**ADDENDUM No. 1**

**ADDENDUM DATE:** June 2<sup>nd</sup>, 2010

**PROJECT:** LCI Service Store  
Fort Drum, New York

**ARCHITECT:** The Smith Sinnett Architecture, P.A.  
4601 Lake Boone Trail, Suite 3-C  
Raleigh, North Carolina 27607

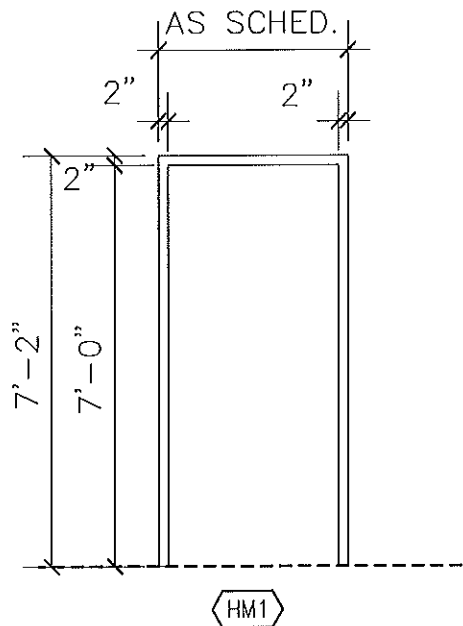
**REVISE** door schedule 1/A4-01 with door schedule 1/A4-01 as attached to this addenda.

**REVISE** frame HM 1 with frame HM 1 as attached to this addenda.
